# STAFF REPORT EAGLE MOUNTAIN CITY

SUBJECT: Skyline Ridge Estates, Preliminary and Final Plats – Public Hearing, Action Item

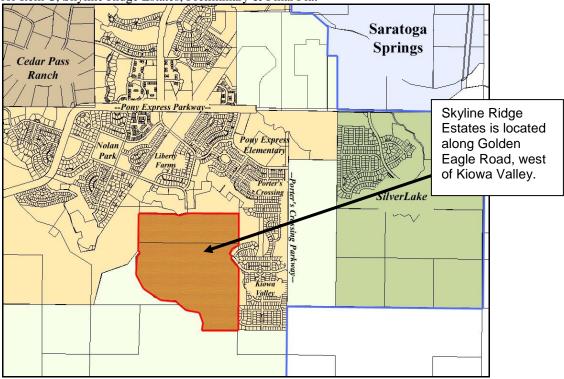
The applicant has proposed a parks plan that includes some, but not all, of these park requirements. Specifically, this park plan includes a 2.43 acre park area with four (4) picnic tables, twenty-three (23) trees, a dual age-group playground, as well as a parking area for twenty (20) parking stalls.

The proposed park plan **does not** show the additional 1.46 pavilions, 1.92 BBQ's, 14.6 stall of bicycle racks, 1.46 volleyball pits, the additional 2.24 trees, and the additional 4.76 picnic table.

Staff recommends: handicap parking stalls be added per ADA standards, the pathway running through the park should connect to the sidewalk/path along golden eagle road for connectivity, that drainage of the parking lot should be addressed, and that the 8' concrete sidewalk on the south side of Golden Eagle Road be connected with.

Our Development Code allows the Planning Commission to recommend, and the City Council approve, park plans that deviate from the requirements. Staff feels that this park plan could be improved by adding additional required park amenities and, if appropriate, paying the difference for any unaccounted items in a fee-in-lieu prior to recordation. Staff's preference would be that the overall cost of the park be implemented into this neighborhood park, however. The Planning Commission may want to express their views of what other items they would like to see installed within this park. One suggestion has been to provide a gravel trail that travels from the end of a culde-sac on the south edge of the development that loops along the hillside and ties back in at a later cul-de-sac. This would allow for not only residents to have access to the hillsides, but also fire control to the brush behind the homes. Perhaps a portion of the remaining park requirements can be met by this trail.
